Adury Fashion & Print Ltd

28 October 2025

Building-13 (AFPL)- six storied building.

Observation 01: Stress in column exceeds normal design limit. Building-13 (AFPL)

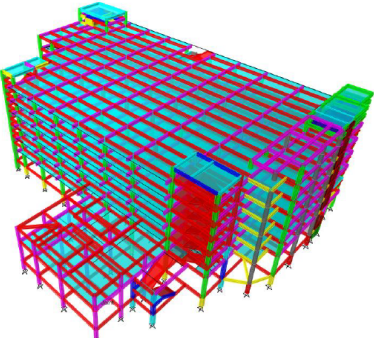
Description: Cursors calculation indicates stress in column exceeds normal design limit at marked location considering prepared floor live load and minimum concrete strength.

The building engineer is required to check the design, loads, and column stress in the structural member based on in-situ material strength and revise the prepared Detail Engineering Assessment (DEA) report accordingly.
